Maricopa Association of Governments  
Building Code Amendments and Standards  
Historical Archive  
2013 Edition

Review Draft

June 19, 2013

**2013 Building Code Amendments and Standards  
Historical Archive  
Table of Contents**

FIGURE R602.3(2)  
FRAMING DETAILS

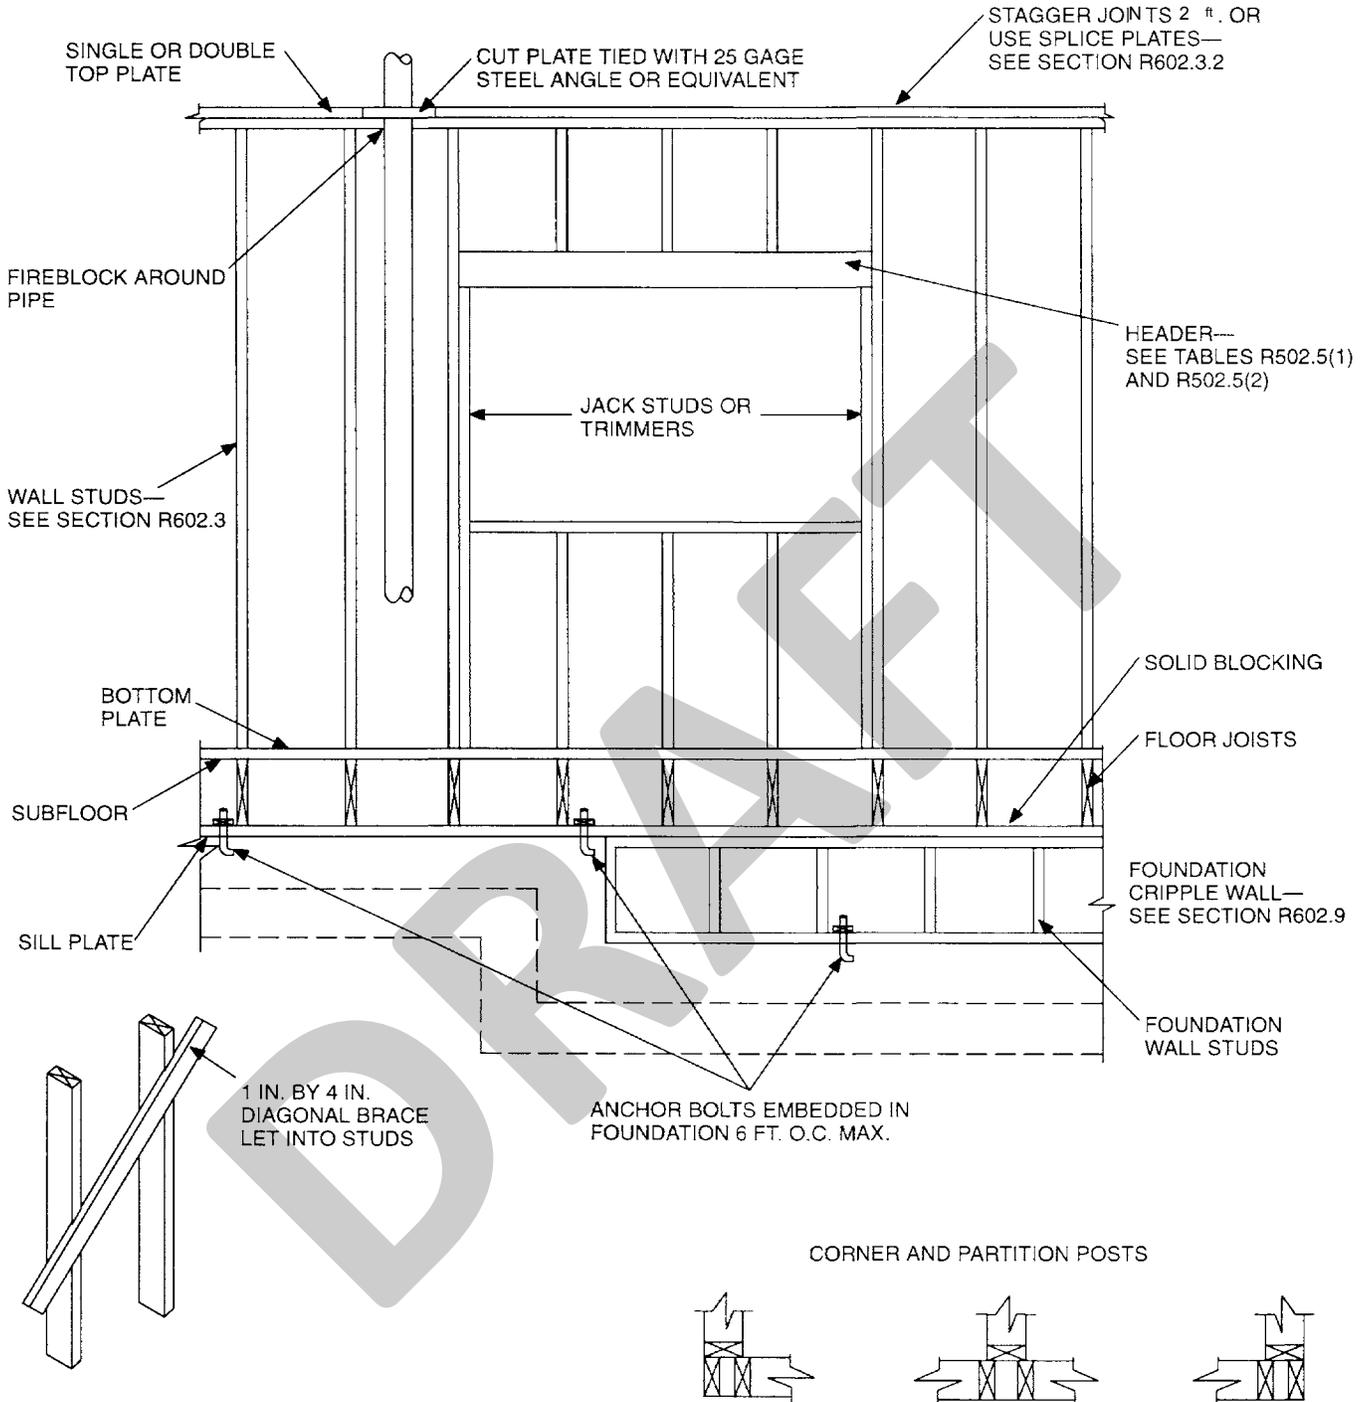
**Proposal: Figure R602.3 (2) Framing Details** The note in the upper right corner of the page is edited to read “STAGGER JOINTS ~~24~~ 24 IN. OR USE SPLICE PLATES—SEE SECTION R602.3.2”.

The remainder of the figure is to remain unchanged.

**Reason:** Section R602.3.2 states, “End joints in top plates shall be offset at least 24 inches (610 mm).” By revising the Figure, the information is consistent with the text of the code.
